Your ref: APP-20232970
Our ref: 12553730

APP-20232970 – Edendale - Wyndham WWTP Section 92 Response

Figure 1 Upstream – Downstream E.coli in Mataura River

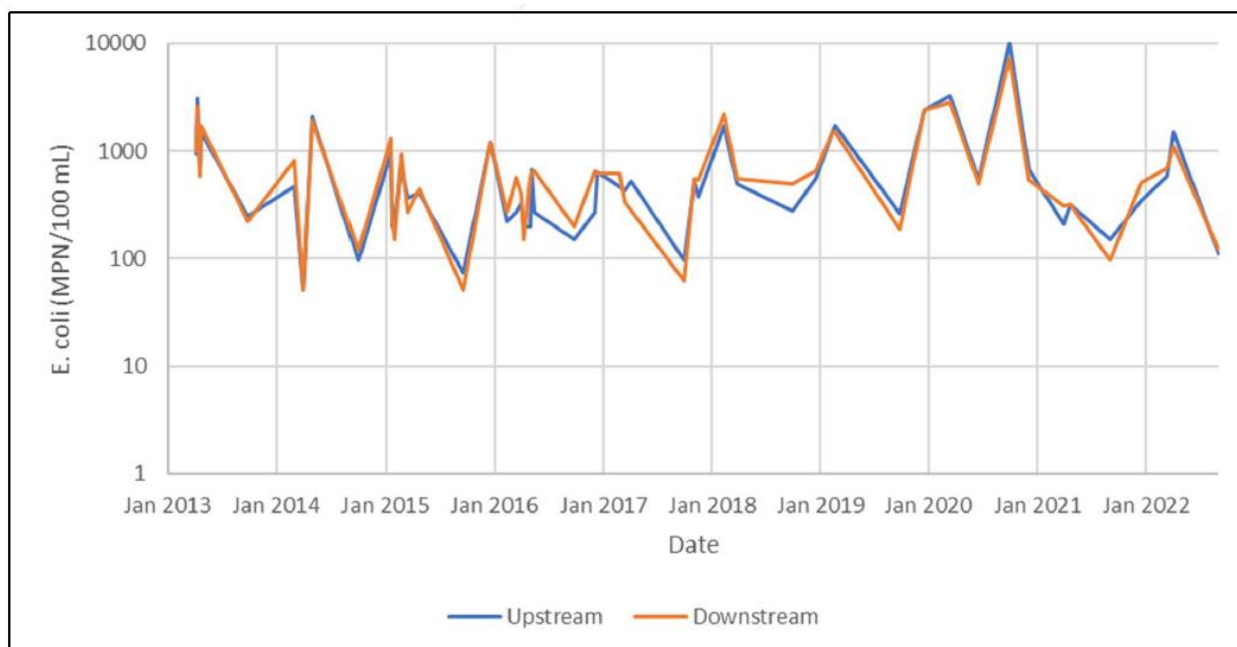
Please provide either:

- I. a complete and thorough explanation along with supporting evidence that confirms existing water quality of the Mataura River upstream of the discharge meets water quality standards in accordance with Policy 15A of the pSWLP and Rule 1 of the RWP. Or;
- II. please confirm that water quality standards are not met and provide an assessment against rule 2 (RWP) and/or Policy 15B (pSWLP).

I am requesting this information to confirm whether rule 1 or 2 applies in the RWP and whether Policy 15A or 15B applies in the pSWLP. It is also worth noting that the application suggests upstream water quality standards are not always met as *E. Coli* data results sometimes exceeds 1,000 MPN/100mL. This suggests that at the very least, policy 15B (pSWLP) applies and not policy 15A (pSWLP).

It has been determined that the discharge meets water quality standards. As such, Rule 1 of the RWP has been assessed which relates to Discharges to surface water bodies that meet water quality standards.

The discharge of any contaminants or water into a surface water body is considered a discretionary activity as the discharge does not exceed Water Quality Standards. Appendix 8 of the RWP sets out the Receiving Water Quality Standards for the Mataura 3. The Appendix specifically states in the introduction section that these standards apply to the effects of discharges following reasonable mixing with the receiving waters, unless otherwise stated. As such, the assessment against Rule 1 must consider if the discharge reduces water quality standards after reasonable mixing and is not based on whether existing water quality upstream of the discharge point meets water quality standards. If this was the case, it would be meaningless in assessing the rule framework as any proposed activities would be classified non-compliant by default if the water quality standards at any point in a water body were already exceeded.

In terms of assessing Rule 1 of the RWP, assessing water quality upstream of the discharge is not relevant to determine if water quality standards are met for the waterbody. The assessment should be based on the effects of discharges following reasonable mixing with the receiving waters to determine if water quality standards for the Mataura 3 will be exceeded. Based on Figure 1, the E. coli counts upstream and downstream of the discharge point generally follow similar trends. The contribution of the discharge volume relative to the flow in the Mataura River will result in immeasurable effects on water quality following reasonable mixing with the receiving waters. The effects of the discharge will therefore not cause an exceedance of the Mataura 3 Water Quality Standards for E.coli. Refer to the response to Question 6 for more detail.

Based on the above assessment, the discharge of contaminants into surface water from a community sewage scheme pursuant to Rule 1 of the RWPS is a discretionary activity. The application for resource consent is therefore assessed against policy 15A of the pSWLP requiring water quality is maintained. Its noted that water quality below the zone of reasonable mixing meets water quality standards for E.coli and will be maintained over the next 5 year period. The application demonstrated that the adverse effects of the discharge are mitigated to reduce concentration loads as the current consented limit of 6,000MPN/100ml will be reduced to 1,000MPN/100ml based on an average count.
